Attachment E

Submissions

From: <[REDACTED]>
Sent on: Monday, November 4, 2024 10:27:37 AM
To: dasubmissions@cityofsydney.nsw.gov.au
Subject: D/2024/854 - 201-217 Elizabeth Street SYDNEY NSW 2000 - Attention Jessica Symons
Attachments: D 2024 854.docx (32.31 KB)

D/2017/349/A (SSD8105-Mod-1) and D/2024/854 (SSD64090972)

Figure 55 Overshadowing Diagrams – 12 and 2pm 21 June

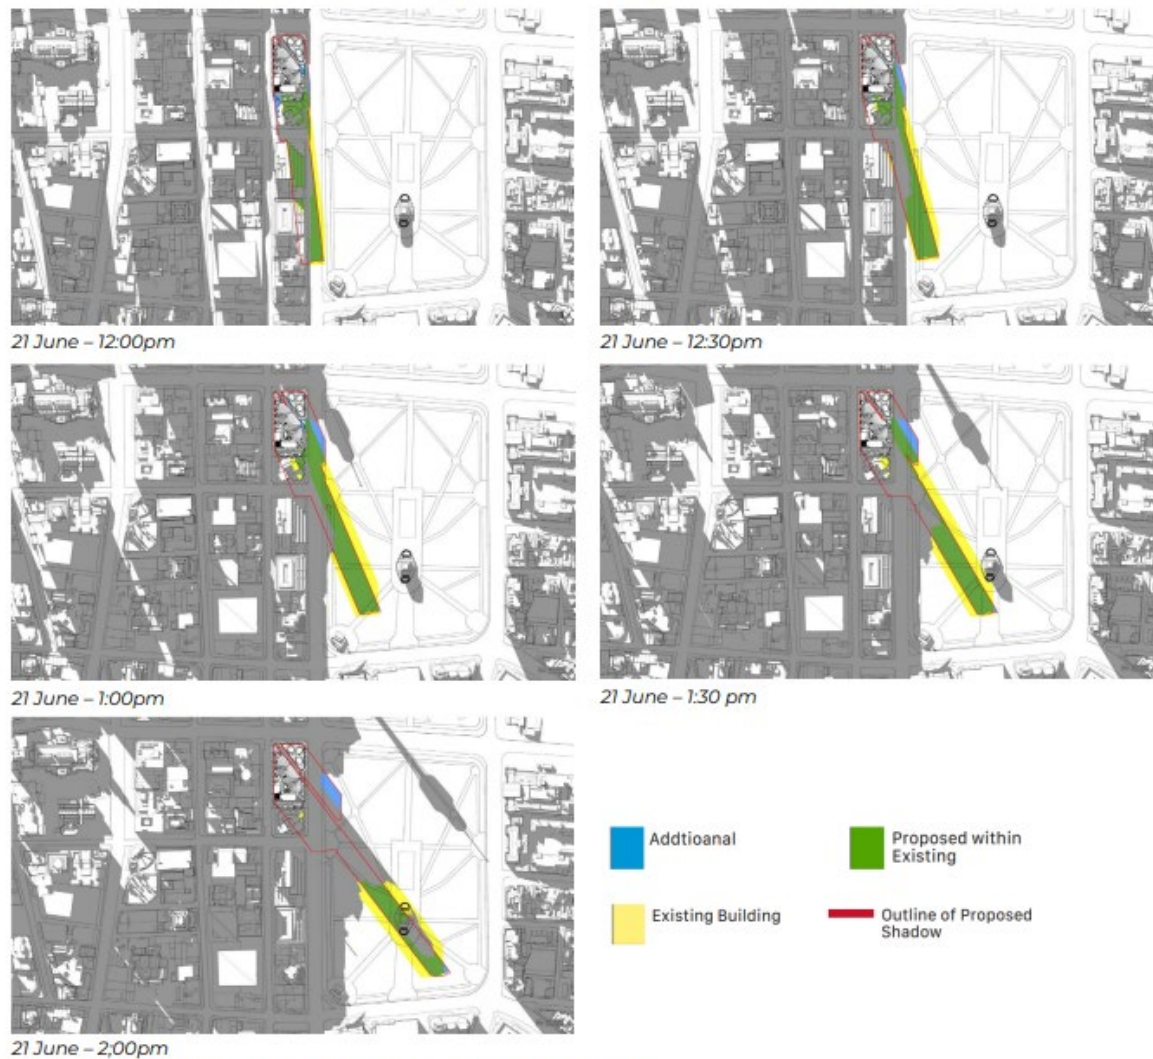
The Applicant's approach to the 50% overshadowing reduction, uses a 'cumulative' calculation, is flawed and inconsistent with the ordinary interpretation of the expression- ...“between (certain hours)”. Words should be given their ordinary and common meaning. Consequently, the requirement for at least 50% reduction in overshadowing commencing at 12:00 on the relevant day and continuing uninterrupted until 14:00 must mean that there is a continuous reduction for the whole period. The Proponent's own shadow diagrams and calculations show non-compliance at least between 12:30 and 13:00.

The Applicant's own shadow diagrams, Figure 55, which are reproduced below, clearly indicates significant overshadowing of Hyde Park in breach of the requirements of the Hyde Park sun access plane from 12 noon to 2 PM on 21 June (shown green). In addition, the diagrams also show new “Additional” overshadowing (shown blue) which breaches the prohibition.

The table of calculations, Table 21, establishes that the proposal would create overshadowing during the 12.00-2.00 period of 13086m², or 1.3086 hectares, during the busiest part of the day for users of the Park! The overshadowing at 13.00 to 13.30 is show as 4,031m², a greater area than the entire site at 201-217 Castlereagh Street which is 3901m².
